MANDATORY SERVICE BULLETIN MSB 40NG-046/2

supersedes MSB 40NG-046/1

Inspection of turbocharger V-clamp.

WORK INSTRUCTION WI-MSB 40NG-046

Figure 6

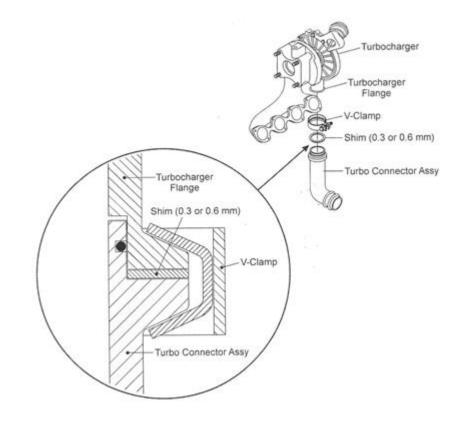
Make sure that the distance between V-flanges on the lock is between 6 and 10 mm (refer to Figure 5). If necessary, insert turbo connector shims to obtain the required distance (refer to Figure 6).

Figure 9

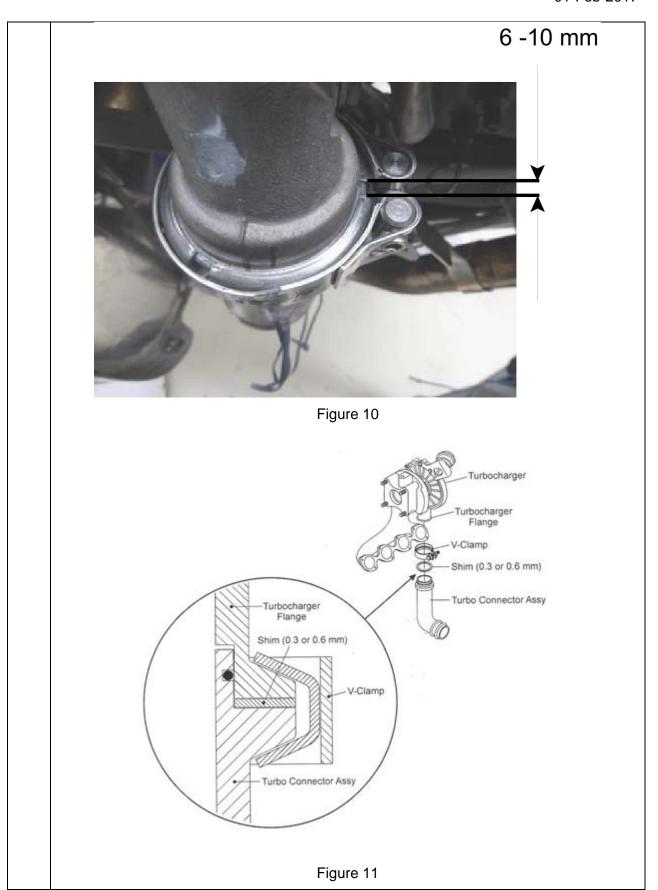
- Position the screw of the V-clamp as shown in Figure 9.
- Before tightening the V-clamp make sure that there is no gap between the aluminium charged air tube and the turbocharger flange. When correctly installed the aluminium charged air tube must fit into the turbocharger flange without tension.
- Tighten V-clamp with 5.5 ± 0.5 Nm $(4.0 \pm 0.4$ lbf.ft).

Figure 12

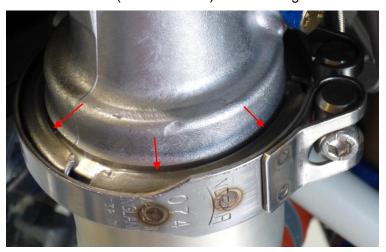
Make sure the circumferential gap to the turbocharger is equal (if not, use rubber mallet to tap V-clamp into position). If tapping with a rubber mallet was required, retighten to 5.5 ± 0.5 Nm (4.0 ± 0.4 lbf.ft). Refer to Figure 12.
